व्यावसायिक परीक्षण रिपोर्ट (प्रारंभिक) COMMERCIAL TEST REPORT

S.R. AGROTECH 5 HP ENGINE MODEL CHAFF CUTTER (Engine Operated)

Report No.: Machine-414/1246 Month: January

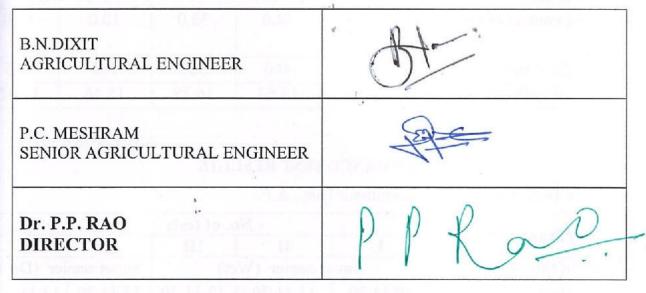
- 15.6 The following dimensions of chute for engine operated chaff cutter are not conforming to the recommendations of Dangerous Machine (Regulation) Rules, 2007 and needs to be looked into.

S. No.	Description	Observation	Remarks
i)	Provision for changing the angle of	Not	Does not
	placement of trough shall be made.	provided	conform
ii)	At the rear side of the trough a support	Not	Does not
	shall be made.	provided	conform
iii)	The trough on the shear plate side shall be	210	Does not
	covered up to a length of 450 mm min.		conform
iv)	The total length shall be min. of 900 mm.	640	Does not
			conform
